CITY OF PITTSBURGH
DEPARTMENT OF CITY PLANNING

ZONING & DEVELOPMENT REVIEW
ZBA REQUESTS SUPPLEMENT
Posse# DCP-ZDR-2020- 02409

Project Description: Giant Eagle wall sign at TechMill

Zone Case #83. of 2020

SOUTH ELEVATION

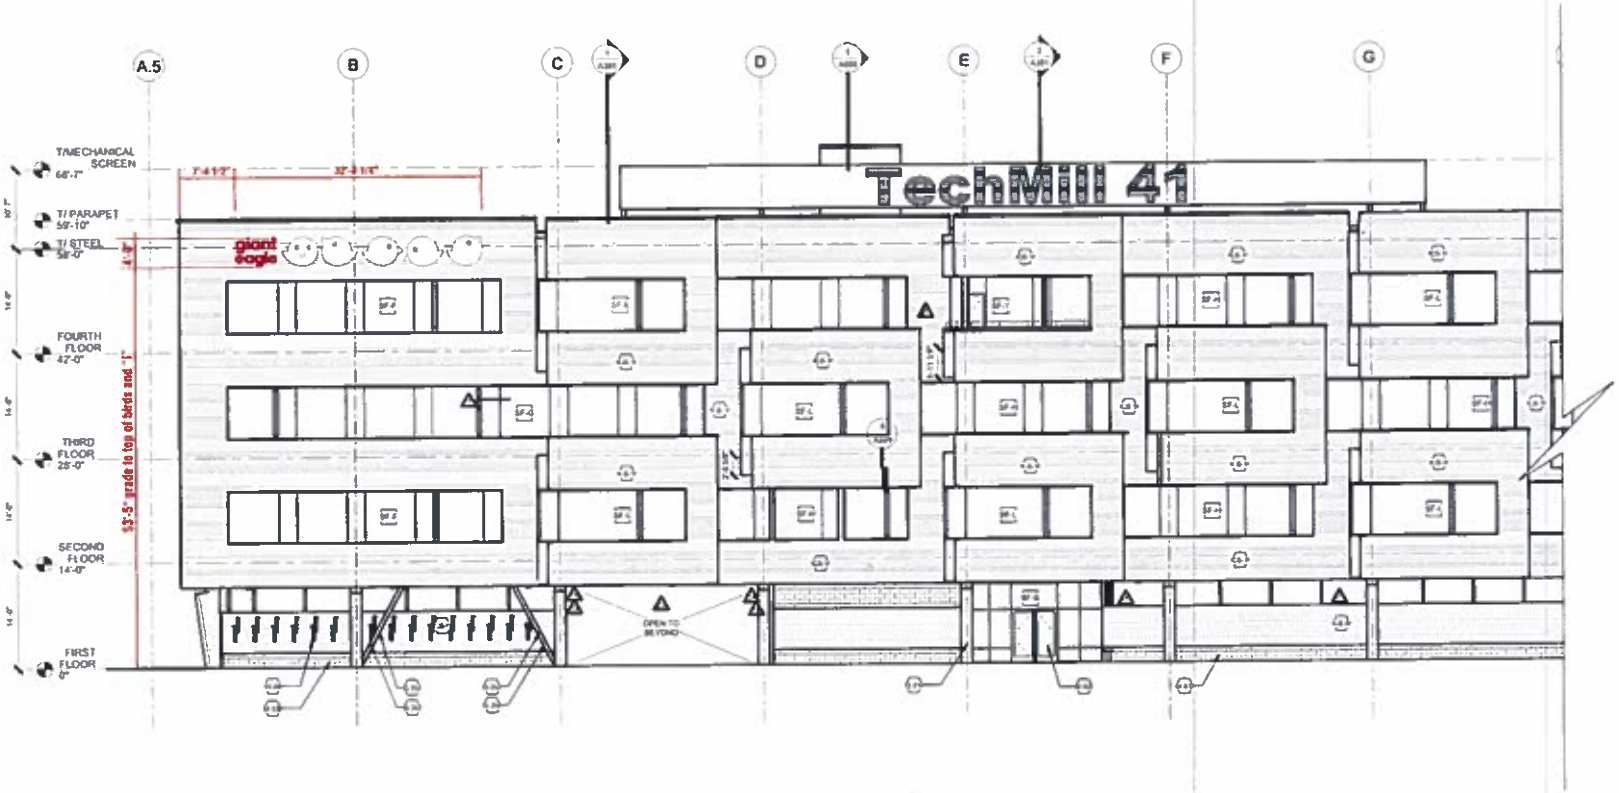
The plans are showing the large "TechMill 41" sign. If that sign is not part of this application, please remove it from the drawings.

Can you provide some detail as to the changing colors on the birds? How frequently would the colors be changing?

Note: The birds are shown white during the day but have the ability to light different colors at night with different colored internal LED's. The giant eagle letters will always remain red, day and night.
